LEE VALLEY REGIONAL PARK AUTHORITY

**REGENERATION AND PLANNING
COMMITTEE**

RP/66/23

PLANNING CONSULTATION BY BROXBOURNE BOROUGH COUNCIL

Appendix B - Building Heights comparison, extracts from Design & Access Statements

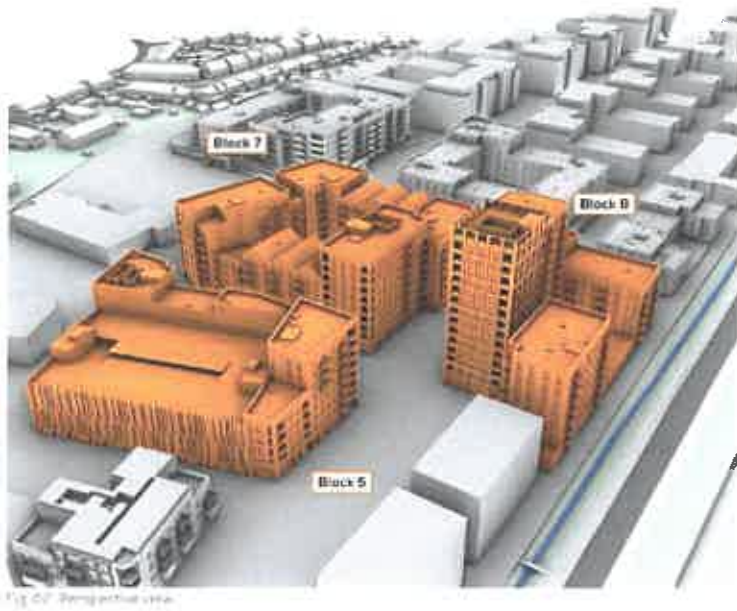
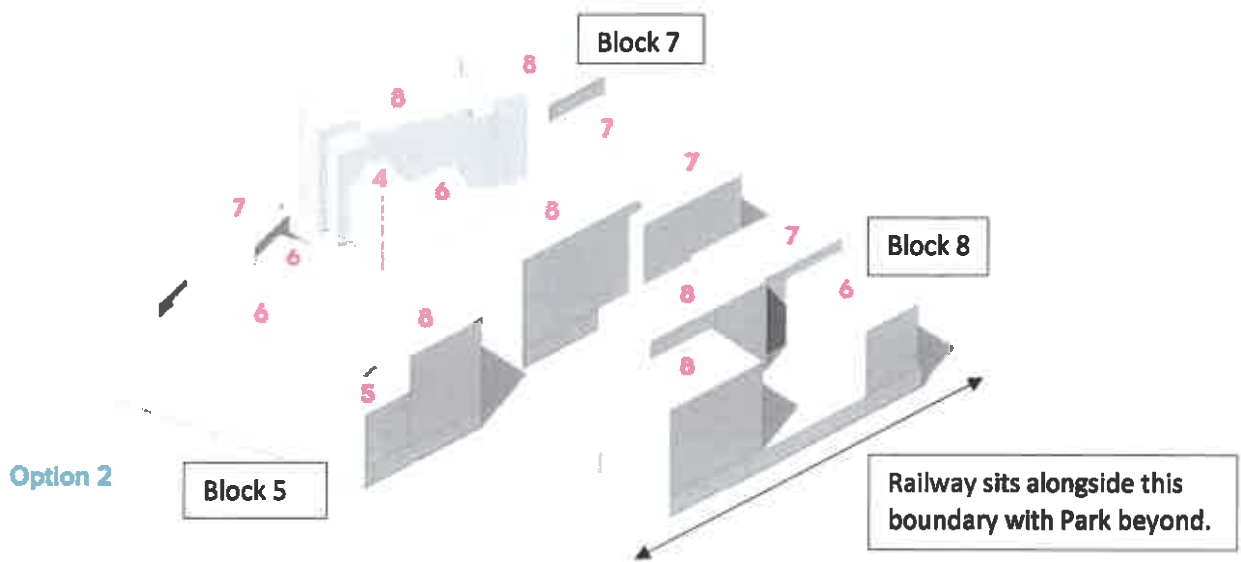
Members will recall that the proposed scheme consists of 3 separate blocks of buildings; Blocks 7 and 8 are located within Parcel 12 and Block 5 within Parcel 13. Originally these Blocks provided a range of heights between 5, 9 and 14 storeys broadly positioned around a new public plaza and green link through to the Parcel 11 in the north. Please refer to the images in Appendix B which show first the original proposed heights and secondly, the building heights of the revised scheme.

- 12 In terms of the Regional Park, the reduction in building heights is most significant in respect of Block 8 where the 14 storey building has been reduced to 8 storeys. Likewise reducing the 9 storey building that sits behind or opposite the landmark building in Block 7 is also helpful in terms of impacts upon the Park, its landscape character and the visual and recreational amenity of visitors. These changes will reduce the visual impact of the development on the adjoining areas of the RLCP and its recreational visitors by lowering the built form to more closely align and sit within the existing wooded edge or buffer to the Park area. These changes are in line with Broxbourne's Local Plan policy CH1 Cheshunt Lakeside which specifies a maximum of 8 storeys, although the parameter plans for the consented scheme set a height limit of 7 storeys. They also accord with the Regional Park's landscape strategy which seeks to protect the coherent and mostly undeveloped landscape character of the RLCP.

- 15 In conclusion the key change sought by the Authority in its objection has been achieved through the proposed reduction in heights within the three Blocks and in particular the lowering of the 14 storey landmark building. In terms of the seasonal visibility issue, it would not be possible to hide or fully screen the visual impact of this development from the Park and its visitors, particularly in terms of views out from those areas of the RLCP immediately adjoining in the winter. A further reduction in height so that the visual issue is overcome is also unlikely to prove viable.

Original Perspective View of building heights below showing 14 storey building in Block B

Amended Scheme Oct 2022 (option 2) showing reductions in building heights
